DELEGATED DECISION REPORT

NMA/2025/0017
Valid 09/04/2025

ALDI STATION ROAD
BUXTON

NON MATERIAL AMENDMENT
IN RELATION TO
HPK/2022/0300

Proposed Site Plan ref. 11551 AEW 1706 0004 Rev V (received 10.09.25)

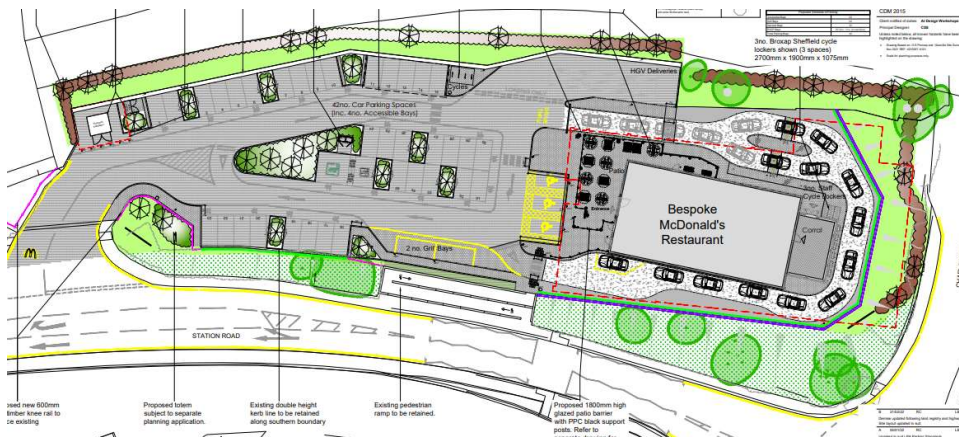
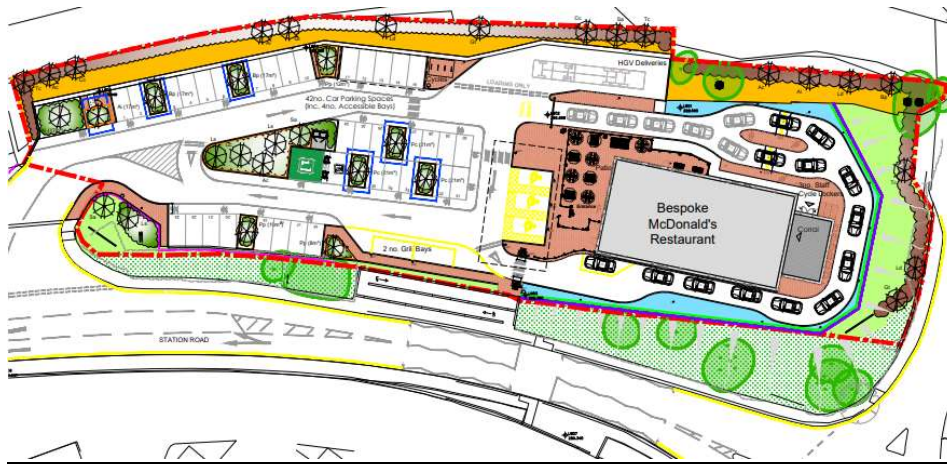
The application seeks a non-material amendment (NMA) primarily for the omission of the substation within the northwest corner of the application site which was previously approved by NMA/2024/0023 on the 30th December 2024. The revised scheme now includes an updated landscaping scheme drawing ref. A5901-01 Rev N for proposed soft landscaping within the area formerly occupied by the substation. In addition, the existing retaining wall adjoining the northern section of the drive thru lane as shown as a dashed orange line on the proposed site plan would be rendered in a milk shade.

The application seeks a non-material amendment (NMA) for the proposed omission of the previously consented substation. In addition, a rendered finish of the retaining wall adjoining the northern section of the drive thru lane is further sought through the NMA submission.

The changes put forward by the applicant in relation to design and appearance matters would maintain, and to a modest degree, create better place making through the omission of the previously approved utilitarian substation building and its replacement with soft landscaping, including tree planting. In addition, an improved finish has been imposed to the exposed boundary retaining wall, which harmonies with existing facing materials onsite. Consequently, the proposals would maintain high quality design as

Proposed Landscaping Plan A5901-01 Rev N Landscaping Scheme (received 2nd September 2025)

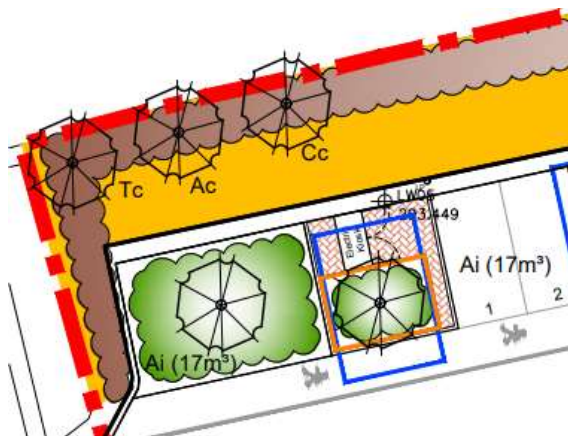
The revised scheme now includes an appropriately updated landscaping scheme in relation to drawing ref. A5901-01 Rev N for proposed soft landscaping, including tree planting within the area formerly occupied by the substation as illustrated below. For consistency purposes, the approved Landscape Maintenance & Management Scheme dated 4th January 2023 has been revised to include the most up-to date landscape plan (Revision B dated 2nd July 2025).

Retaining Wall Proposal (received 2nd September 2025)

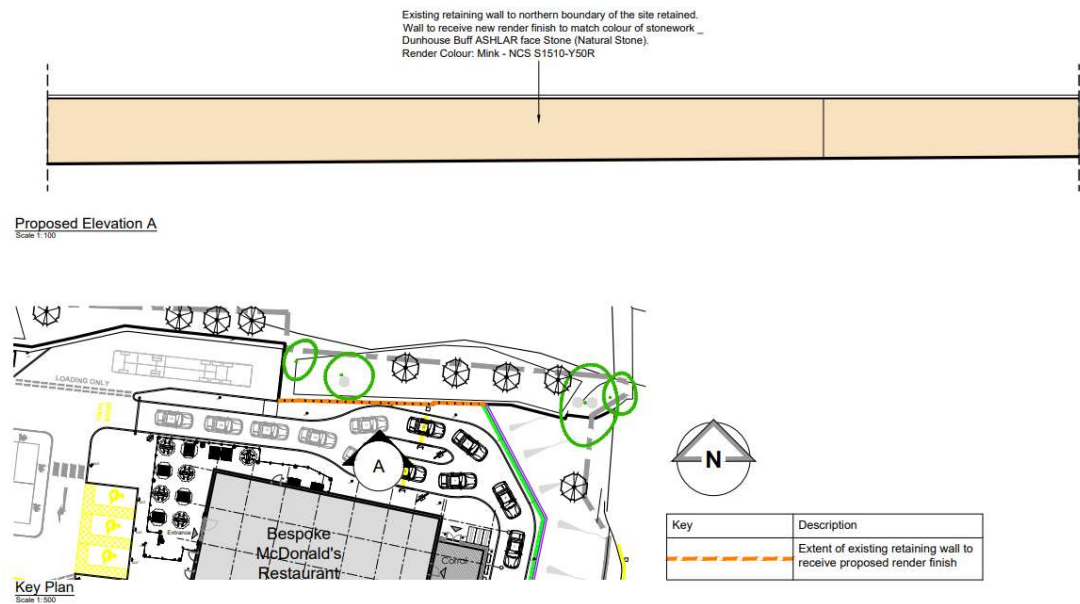
The existing retaining wall adjoining the northern section of the drive thru lane as shown as a dashed orange line on the site plan has been rendered in a colour to match the approved stone of the main building in a mink shade.
